**HISTORIC DISTRICT
REVIEW COMMISSION**

**HISTORIC DISTRICT REVIEW COMMISSION
Revised Regular Meeting Agenda**

HDRC Case No. 19-010D

Application: Certificate of Appropriateness for a new retaining wall & driveway alterations
Applicant: Skillman Homes
Location: 118 N. Morse
District: Dougherty
NRHP Status/category: Contributing
File Date: June 7, 2019

Proposed Retaining Wall, 118 N Morse

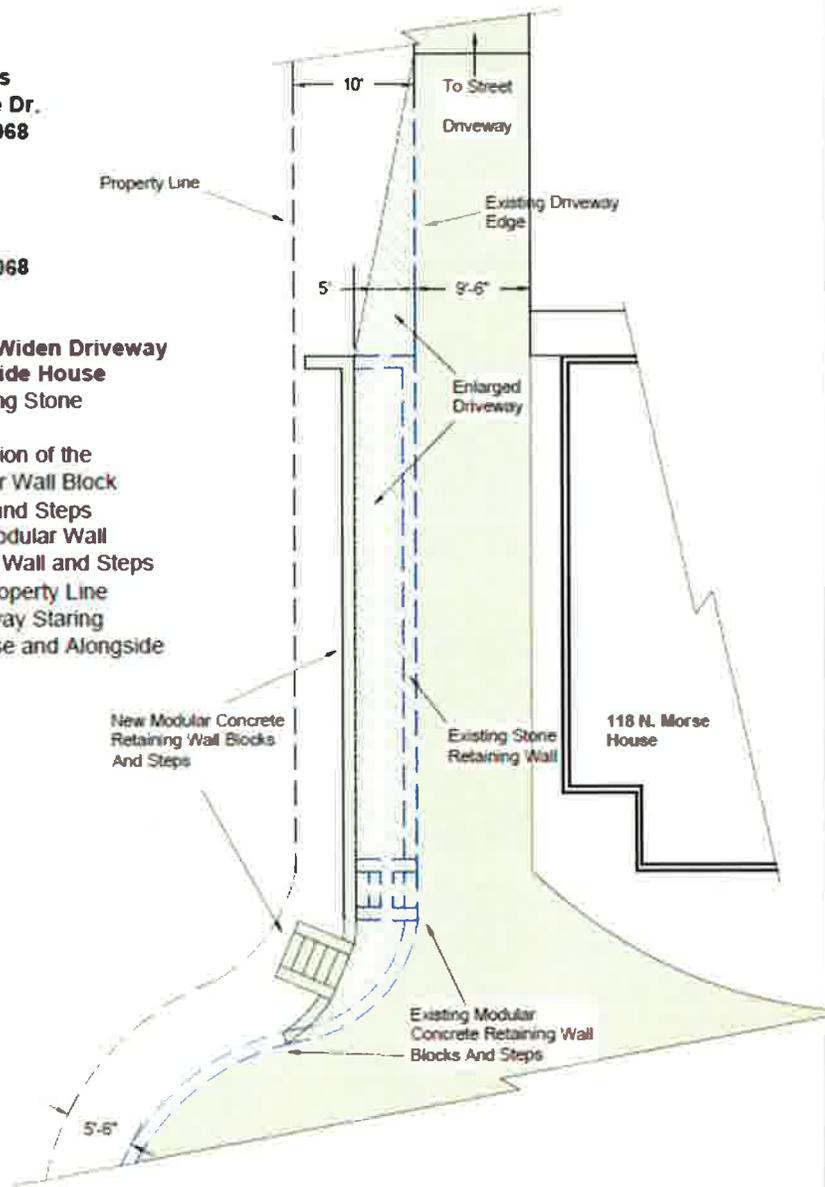
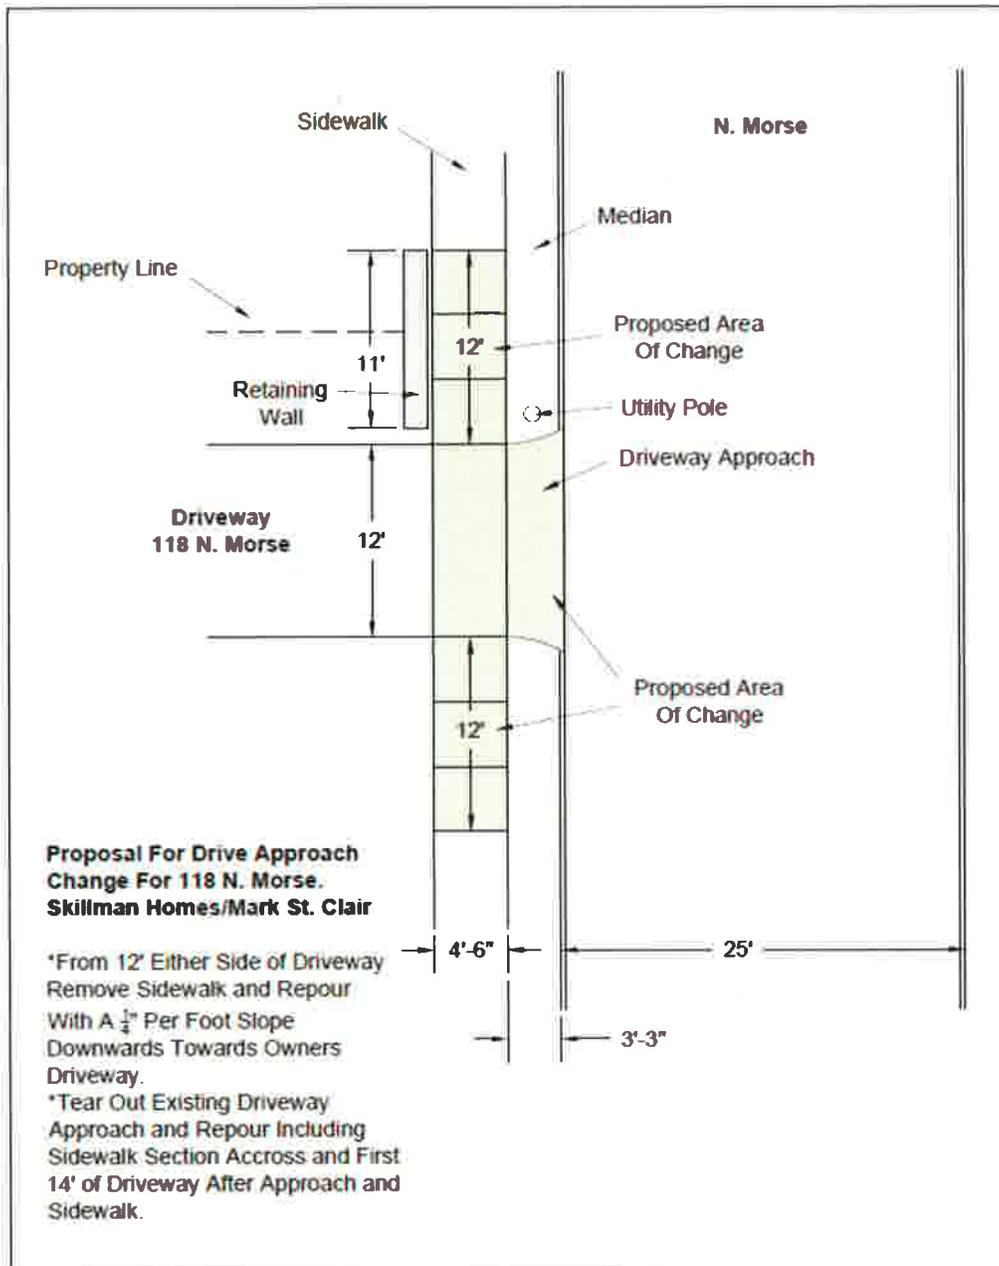
Staff recommends approval of the application with the following stipulations; no interlocking stone is used in the new wall and that a 4' greenspace remains between the driveway and the property line. With these stipulations the application meets the standards for review and guidelines; therefore staff recommends approval of HDRC case #19-010D.

Gutter Repair /
 Replacement
A7.4

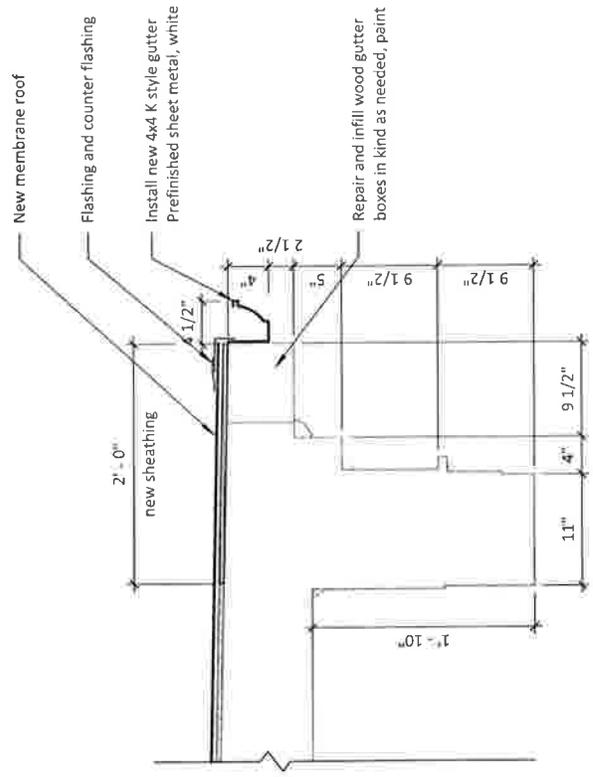
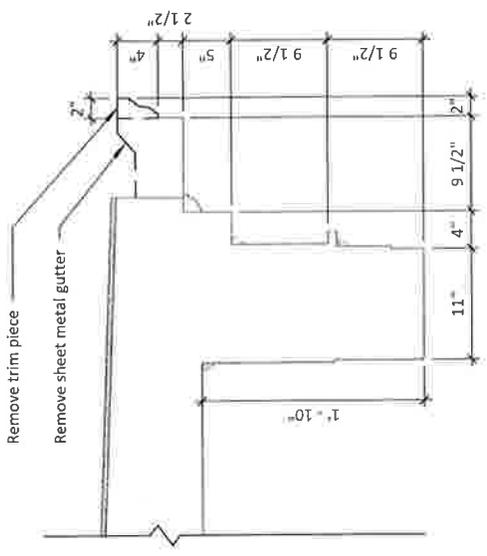
Staff recommends approval with the stipulation that the new gutters should not remove or cover any significant historic trim. With this stipulation, staff recommends approval of HDRC case #19-010LS.
